# Office Action Summary

10/539,552

LEE ET AL.

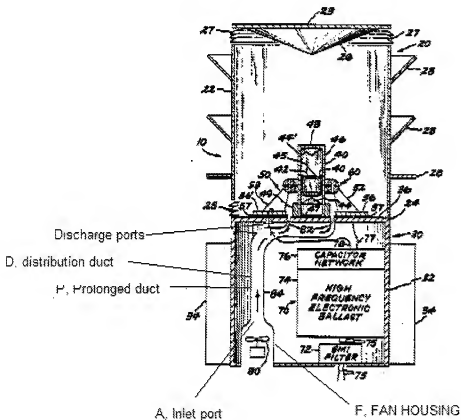
1. Figure 1 should be designated by a legend such as --Prior Art-- because only that which is old is illustrated. See MPEP § 608.02(g). Corrected drawings in compliance with 37 CFR 1.121(d) are required in reply to the Office action to avoid abandonment of the application. The replacement sheet(s) should be labeled "Replacement Sheet" in the page header (as per 37 CFR 1.84(c)) so as not to obstruct any portion of the drawing figures. If the changes are not accepted by the examiner, the applicant will be notified and informed of any required corrective action in the next Office action. The objection to the drawings will not be held in abeyance.
